AXOD/AXODE (AX4S) UPDATE HANDBOOK

*Updated
October, 2002*

Since the introduction of the Ford AXOD transaxle in model year 1986, there have been many major engineering design changes that have affected many of the parts used in the AXOD transaxle. This version of the AXOD "Update Handbook" begins with the 1986 model year and will explain each change, the parts affected by the change, and any parts interchange problems created by the change. This booklet is an updated version of the original.

Figure 86

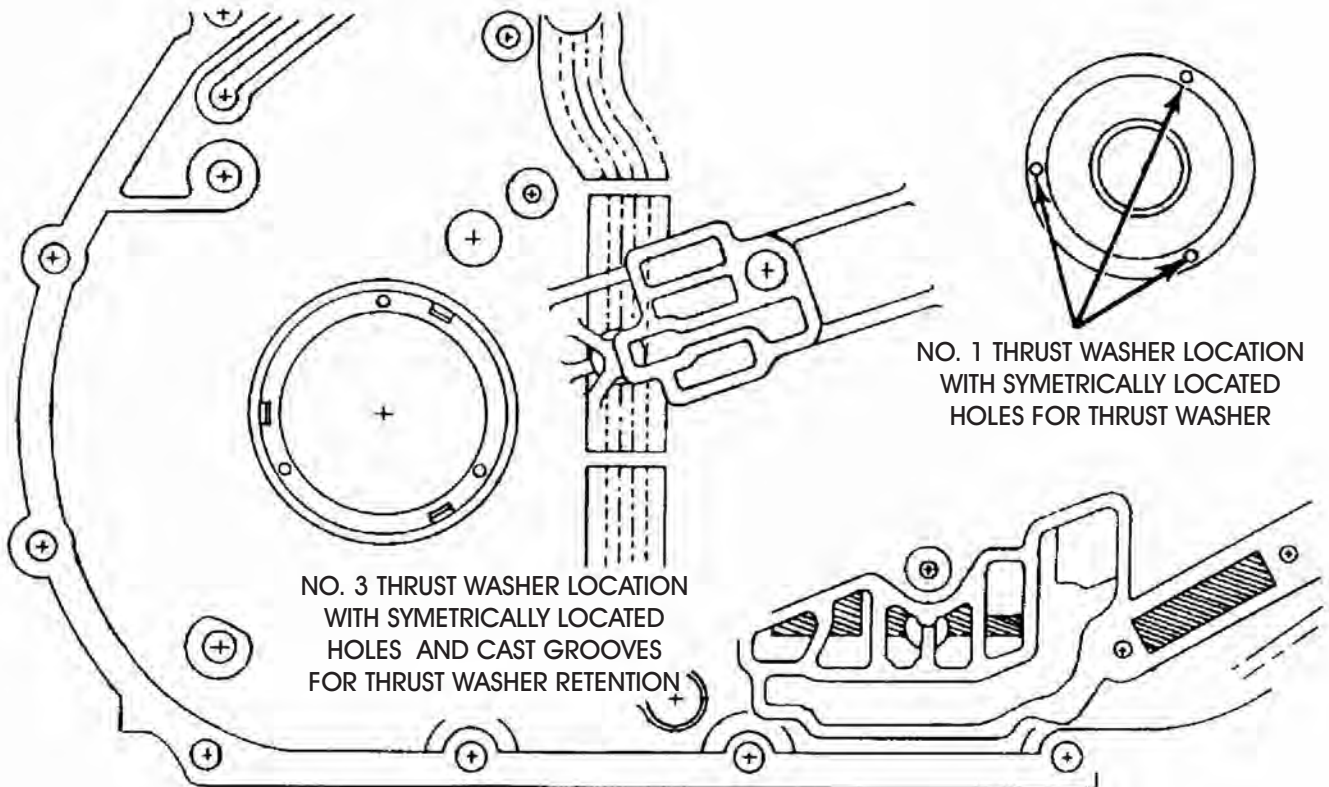
If replacement of the number 1 and/or the number 3 thrust washer becomes necessary, inspect the chain cover in the thrust washer tab areas to determine the correct thrust washers required. Refer to Figures 85 and 86.

Figure 89

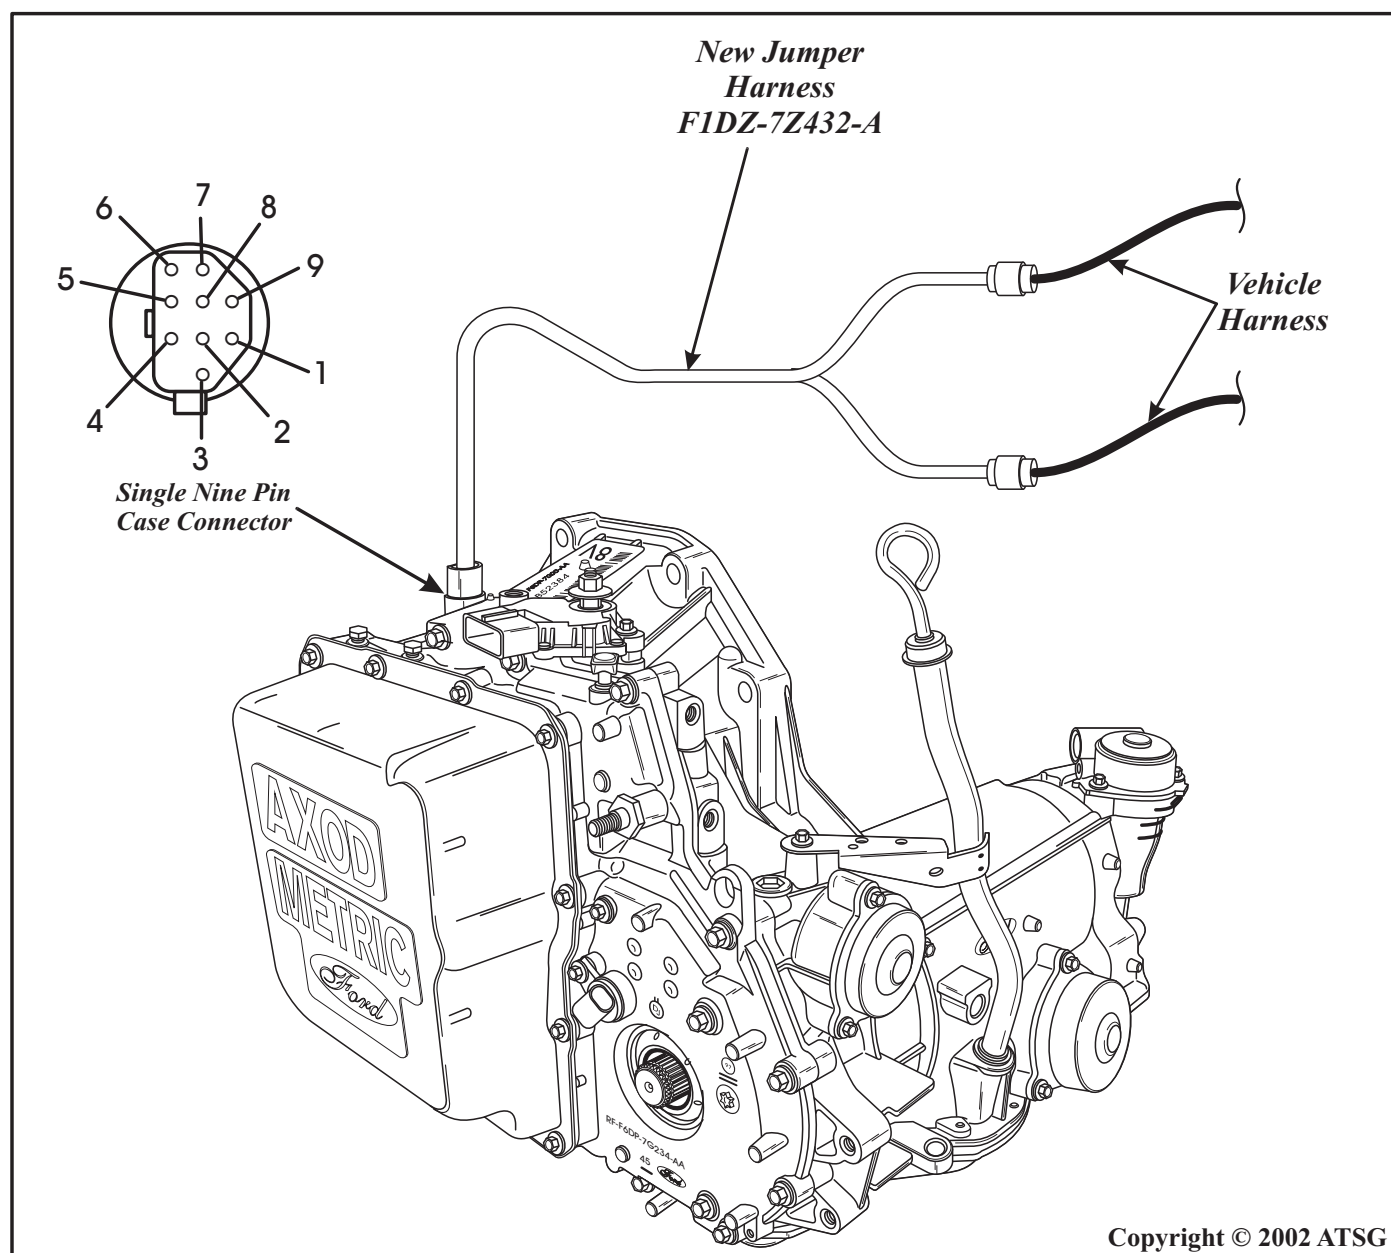
If service requires replacement of the chain cover on a 1991 or 1992 AXODE transaxle, it must be replaced with a 1993 design level AXODE chain cover assembly kit. The 1993-Up design level chain cover has only one nine pin external electrical connector located at the top of the transaxle as shown in Figure 89, and the previous side connector, as shown in Figure 88, has been eliminated. This requires a new "Y" harness, which is included in the service package "Kit", to make it compatible with 91-92 vehicles. The new design "Y" harness is also illustrated in Figure 89.

Figure 90

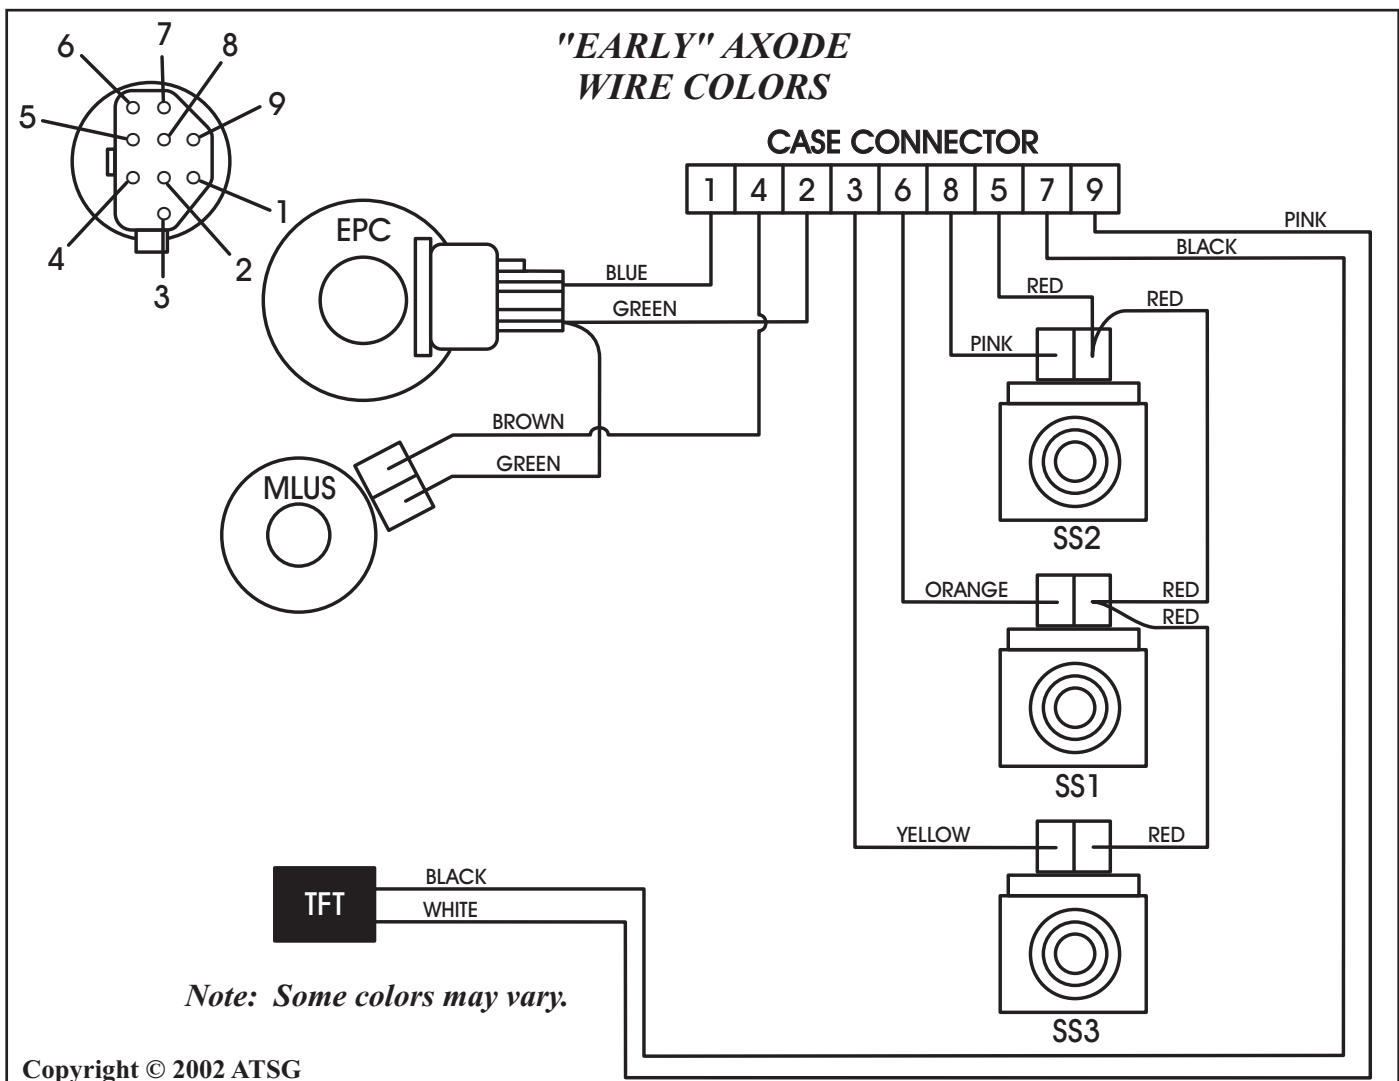
CORRECTION: Connect the internal wiring harness connectors to their proper solenoids, *using the wire colors*, as shown in Figure 90 and 91. Proper connection of solenoids can also be verified externally through the case connector using the Ohms chart in Figure 91.

Figure 94

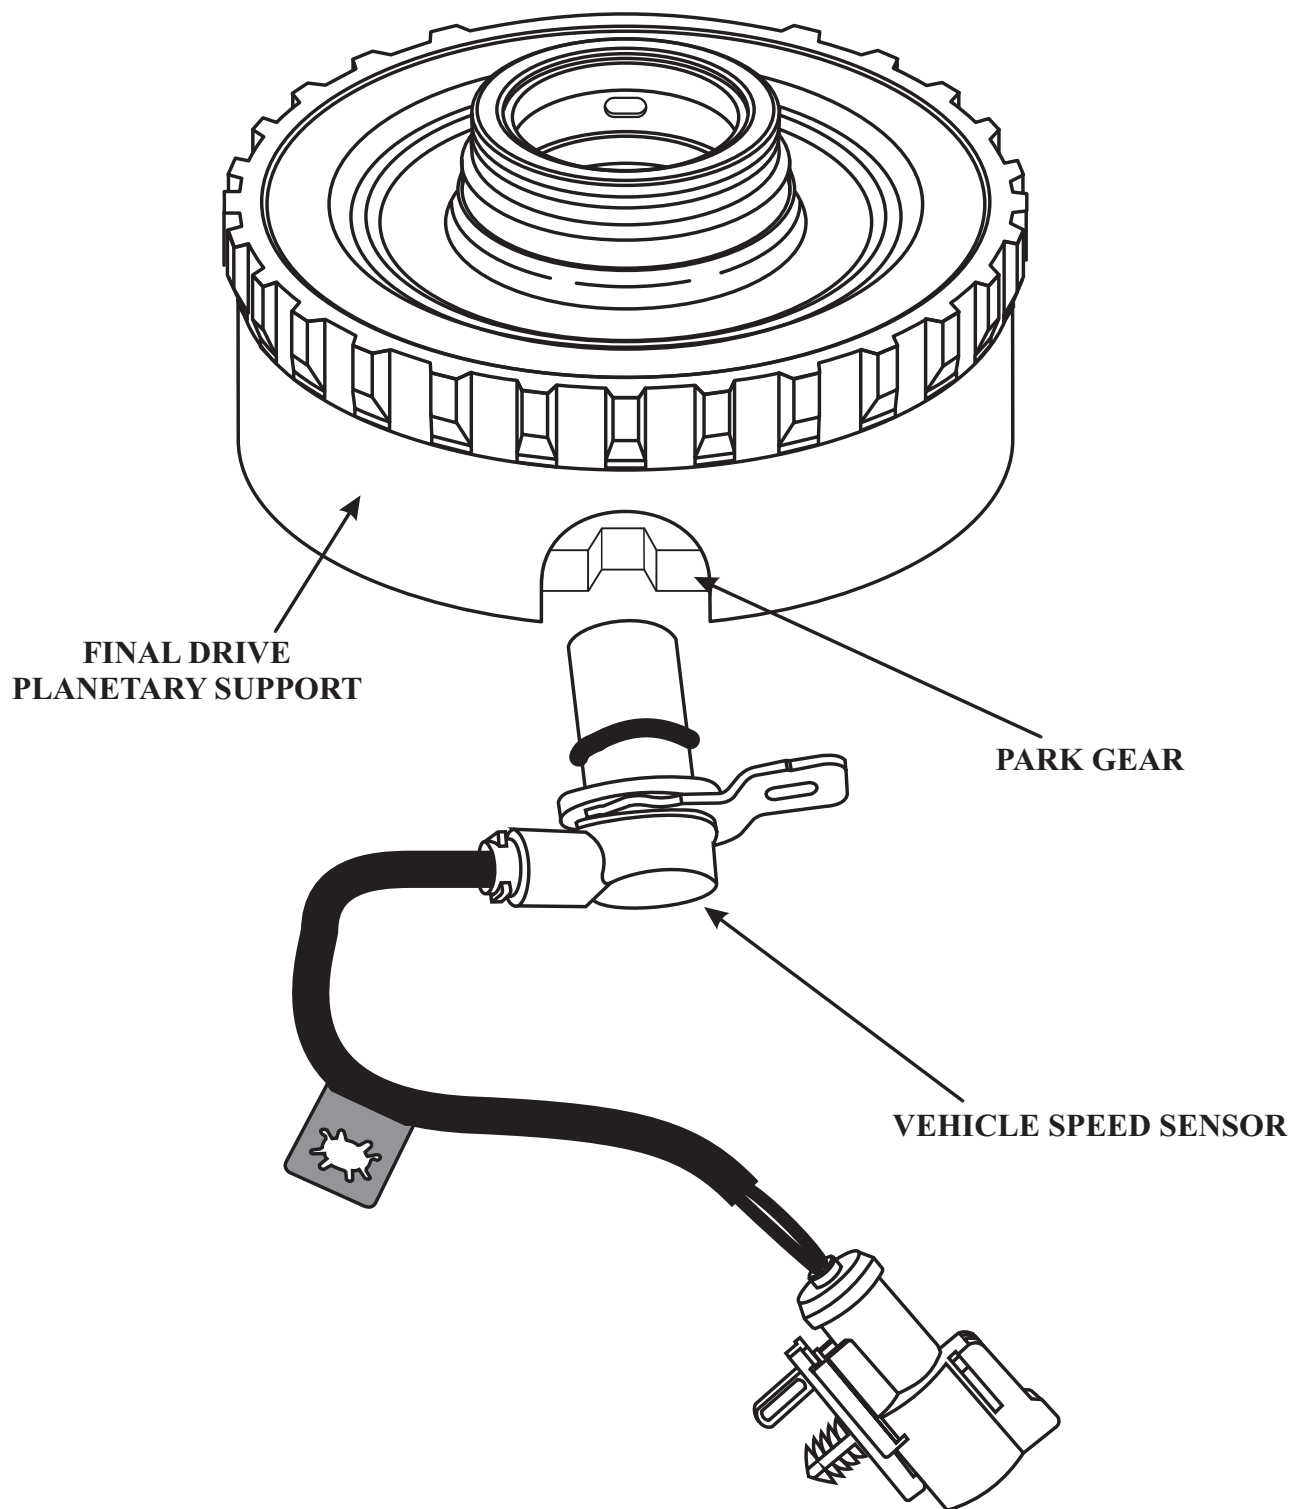
- (1) TRANSAXLE CASE - Changed to accommodate mounting the new design speed sensor so that it is in line with the planetary support and the park gear.
- (2) FINAL DRIVE SUPPORT - Changed to accommodate mounting the new design speed sensor and now has a "*cut out*" for the speed sensor to look through at the park gear, as shown in Figure 94.

Figure 97

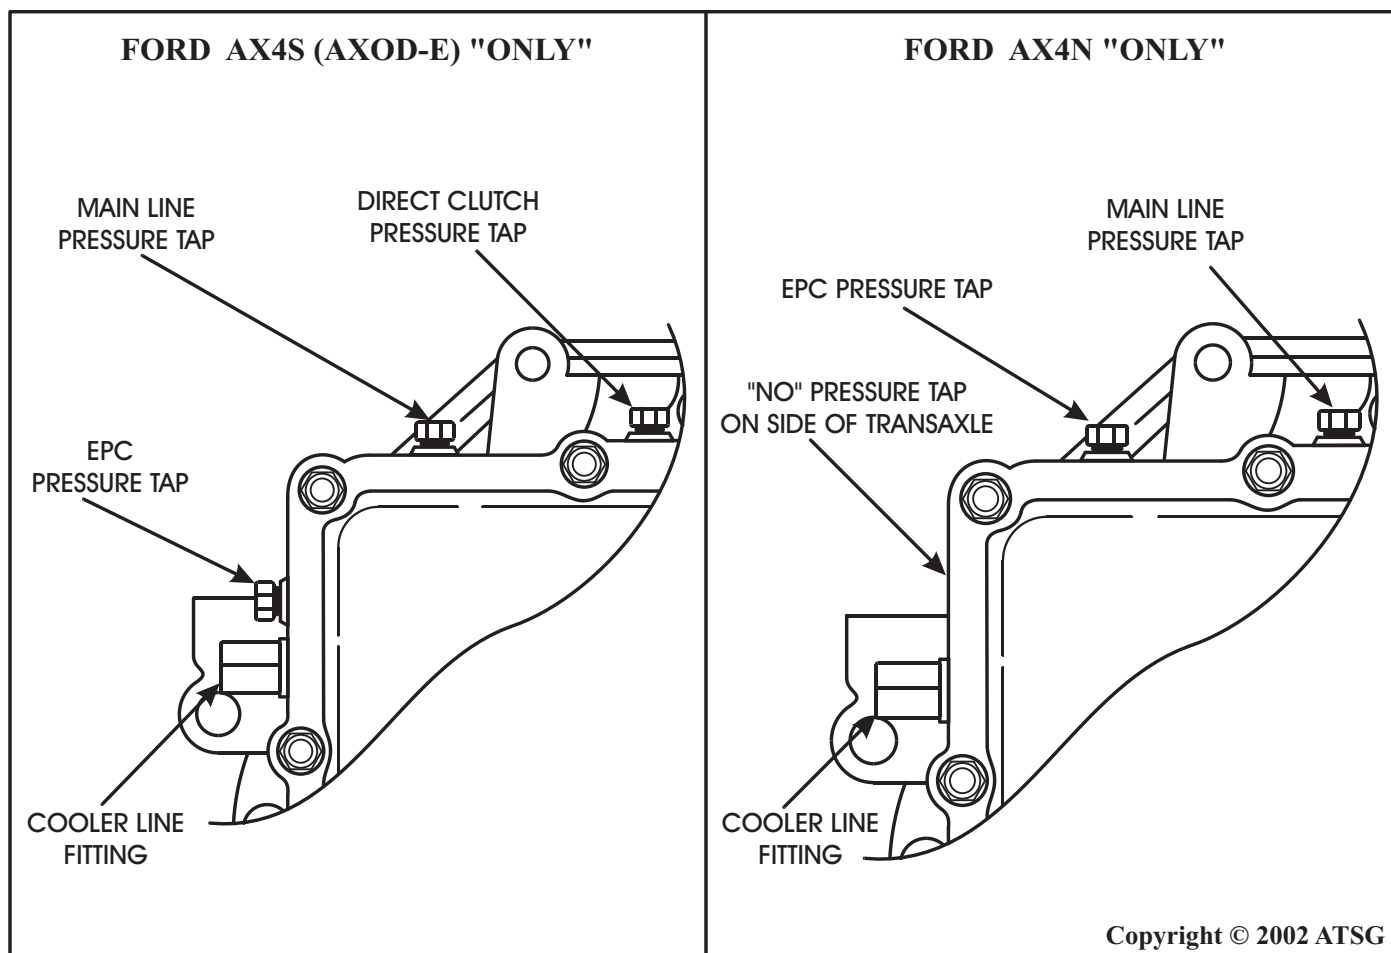
Most technical manuals, including Ford Motor Company manuals, have the pressure tap locations identified wrong. Use the this page to correct your manuals at the shop for the correct pressure tap locations.

Refer to Figure 97 for the AX4S (AXOD-E) transaxle pressure tap locations.

Figure 101

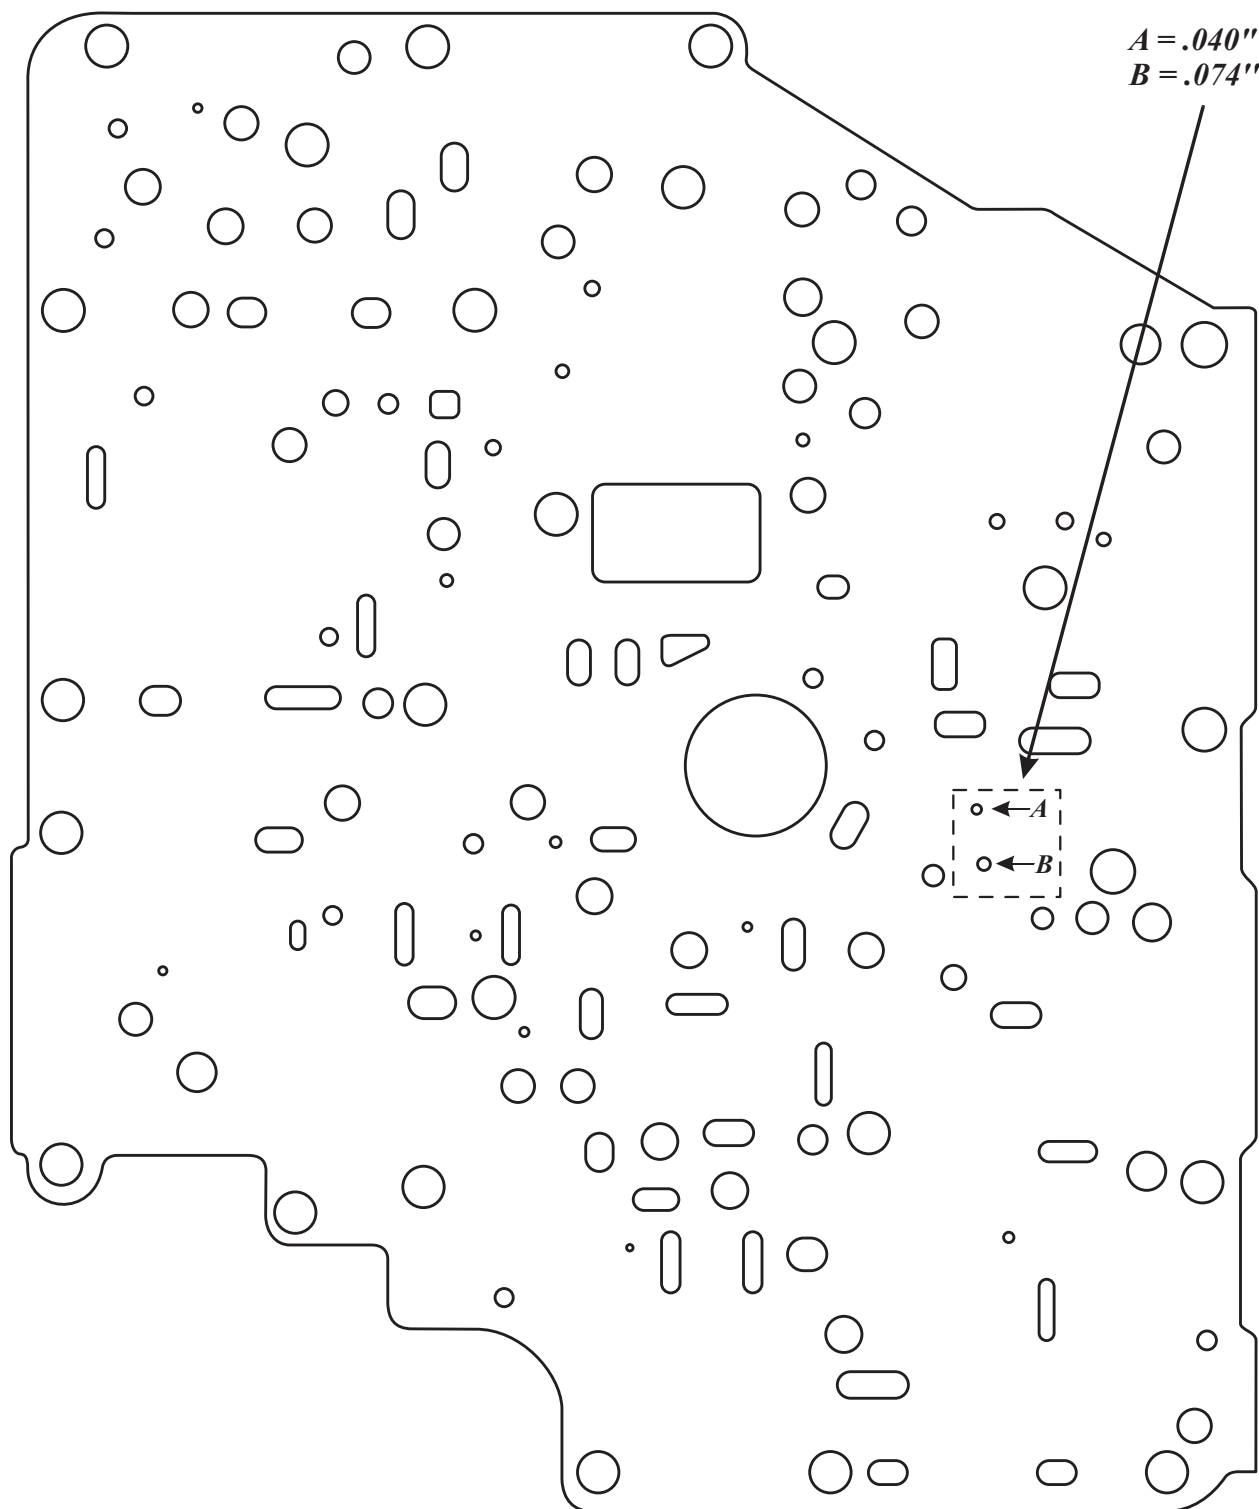
COMPLAINT: Some 1995-Up Ford Windstar Vans may exhibit a harsh 1-2 upshift, either before and/or after overhaul of the transaxle. Some 1995-Up Ford Taurus, Mercury Sable or Lincoln Continental may exhibit a soft or flare on the 1-2 upshift either before or after overhaul.

CAUSE: The cause may be, a valve body spacer plate designed for the Taurus, Sable, Continental passenger car family, has been installed on a Windstar Van, creating a harsh 1-2 upshift. If the Windstar Van valve body spacer plate, is installed on the Taurus, Sable, Continental family of vehicles, the result will be a soft or flared 1-2 upshift. ***Obviously these two spacer plates are different.*** Refer to Figures 101 and 102, using the two holes over the 1-2 capacity modulator valve area, for identification.

CORRECTION: Install the proper valve body spacer plate for the Ford family that you happen to be servicing at this time. Refer to the illustration in Figure 101 to identify the valve body spacer plate for the Windstar Van. Refer to the illustration in Figure 102 to identify the valve body spacer plate for the Taurus, Sable and Continental family.
